Cobra Motorcycle Mfg.

TSB0811 2011 Connecting Rod Wrist Pin Bearing

Technical Service Bulletin

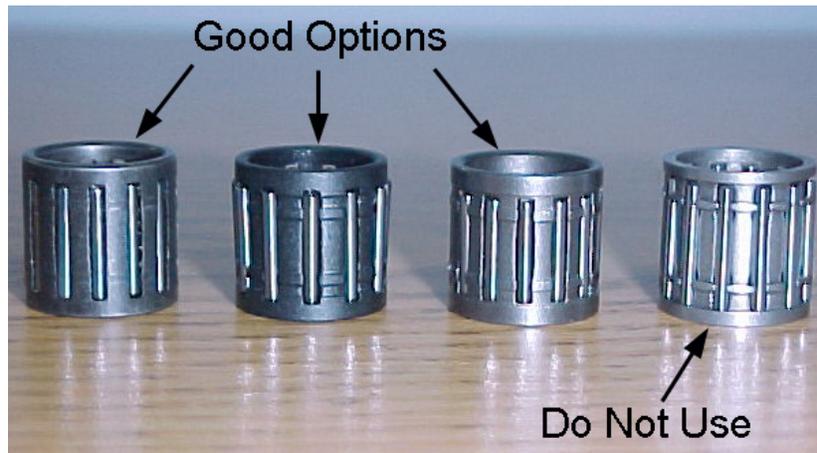
The bearings are noticeably different as can be noticed in the picture below.

Customers needing an immediate solution can also purchase an acceptable wrist pin bearing from Wiseco (their part number B1041). Be sure to replace the wrist pin circlip with a new one for reassembly (Wiseco part number CW12)
